City Council Workshop

Unified Development Code Policy Amendments

September 4, 2025

Screening Example

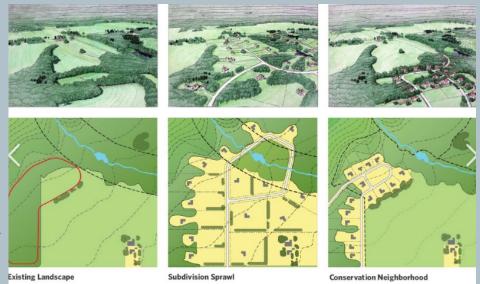
What is the problem: Several sections reference solid or opaque screening and lacks consistency in ensuring privacy of adjacent residential lots.

Council Direction: Provide a recommendation ensuring screening consistency, choose solid or opaque.

Proposed UDC Amendment: Enhanced all landscape screening to opaque landscape screening.

CDA Example Source: Better Town Toolkit

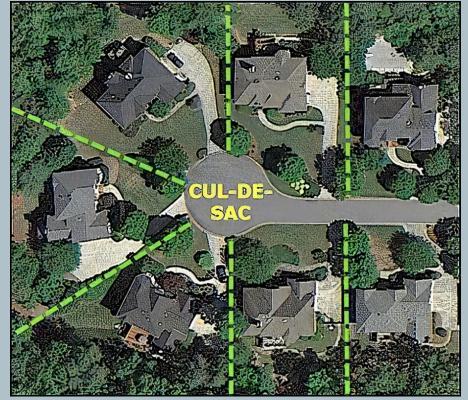
What is the problem: A minimum blended average of lot sizes with no specified minimum lot size may result in developers incorporating smaller and non-uniform lots. Clarify the density calculation.

Council Direction: Recommend a minimum lot size instead of blended averages.

- •Removed non-technical standards of blended averages.
- •Enhanced specific requirements for maximum gross density and minimum lot size (0.5 acre for Neighborhood Residential Zone, 1.75 acres for Rural Residential Zone).
- •Clarified the total net lot area.
- •Refined how to calculate gross density and number of lots.
- •Updated the minimum required conservation area from 30 percent to 40 percent.

Cul-De-Sac Exception Example

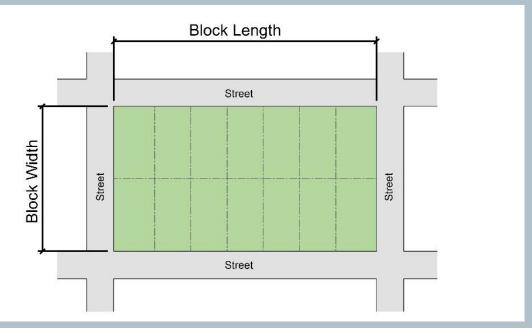
What is the problem: Lots served by private well and/or private septic are required to have a minimum street frontage of 150 feet or 200 feet. Clarification is needed regarding minimum street frontage along cul-de-sacs.

Council Direction: Provide a recommendation for street cul-de-sac street frontage.

Proposed UDC Amendment: The minimum is 100-feet for lots on a cul-de-sac or knuckle-sac.
